Company	Trenz Electronic GmbH
PCN Number	PCN-20250520
Title	TEIB0006-02 to TEIB0006-03 Hardware Revision Change
Subject	Hardware Revision Change
Issue Date	2025-05-26

Affected Product	Replacement
TEIB0006-02	TEIB0006-03-A

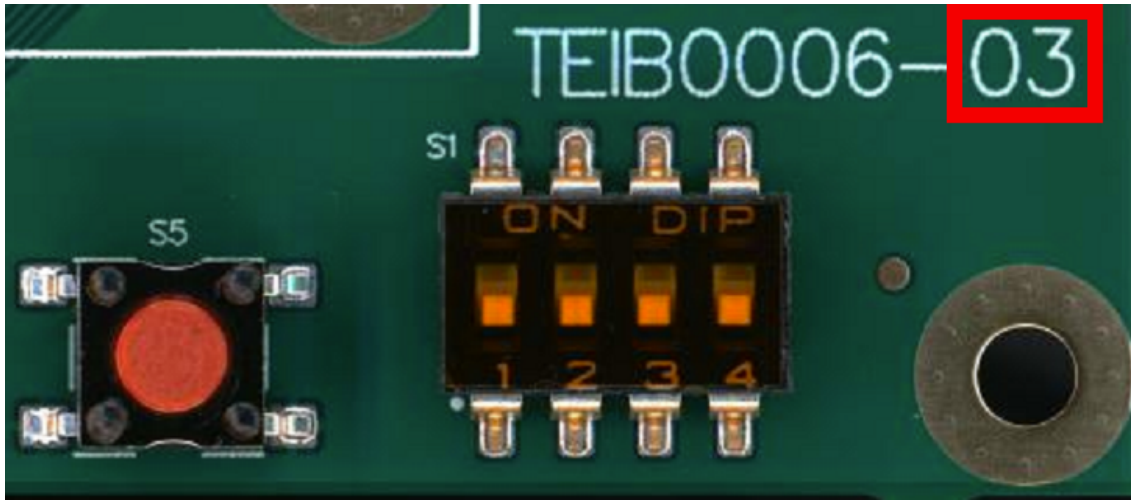
#22 Added UKCA-logo and ESD protection logo.

Type: PCB Change

Reason: Improve product classification identification.
